Subject: MHI's Responses to US-APWR DCD RAI No. 319-2147 REVISION 1

Reference: 1) "REQUEST FOR ADDITIONAL INFORMATION NO. 319-2147 REVISION 1, SRP Section: 09.05.06 - Emergency Diesel Engine Starting System, Application Section: Tier 2 Section 9.5.6", dated April, 6, 2009

US-APWR Design Certification

Figure 9.5.6-1 Gas Turbine Generator Starting System Schematic Diagram

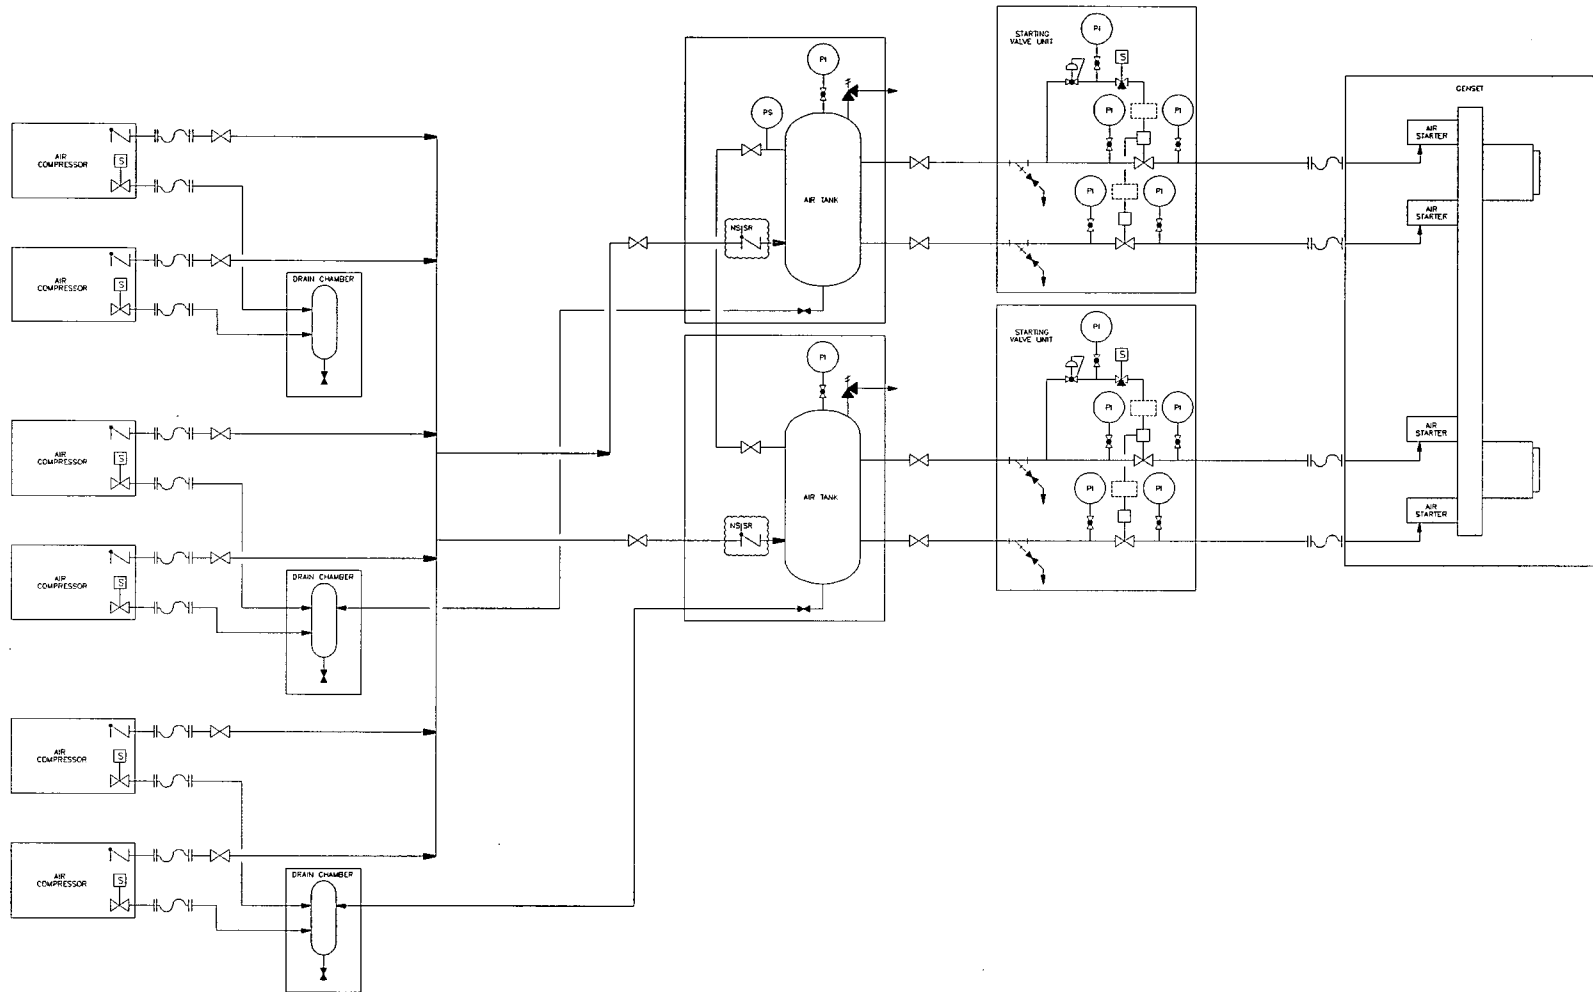
- It is stated in FSAR Tier 2 Section 9.5.6 that each GTG starting system includes four air starting units. According to Figure 9.5.6-1, there are only two starting air units per GTG.

- It is stated in FSAR Tier 2 Section 9.5.6.2.2 that each compressor keeps one receiver pressurized. However, this is not consistent with Figure 9.5.6-1. According to Figure 9.5.6-1, all six compressors feed both air receivers via a common header with no isolation between air compressors.

FSAR Tier 2 Section 9.5.6.2.2 describes a check valve in the receiver charging line. These valves are not shown on Figure 9.5.6-1. Due to the critical function of these valves, they should be including on Figure 9.5.6-1.

FSAR Tier 2 Section 9.5.6.2.2 states that "the valves in the compressor discharge header can be aligned manually so that either air receiver can be recharged from either air compressor." "Either" air compressor implies that there are only two compressors and should be corrected. In addition, the compressors are all headered together according to Figure 9.5.6-1 and all together supply both receivers. Or any one of the compressors can feed both air receivers. Verify that all of the valves described in Section 9.5.6.2.2 are shown on Figure 9.5.6-1 and that the normal valve positions indicated on the figure are correct and consistent with the description.

FSAR Tier 2 Section 9.5.6.3.C notes that the GTGSS is seismic Category I and ASME Section III Class 3 except for the air compressors and air coolers. In accordance with SRP Section 9.5.6, the piping interfaces between seismic and non-seismic as well as between ASME Section III and non-Section III should be indicated on the P&ID (Figure 9.5.6-1).

Figure 9.5.6-1 will be revised to add checks valve in the receiver charging lines.

Figure 9.5.6-1 will be revised to add check valve based on Question No.09.05.06-13

Figure 9.5.6-1 will be revised to indicate the piping interfaces between seismic and non-seismic as well as between ASME Section III and non-Section III.

Figure 9.5.6-1 will be revised as shown in Attachment B.
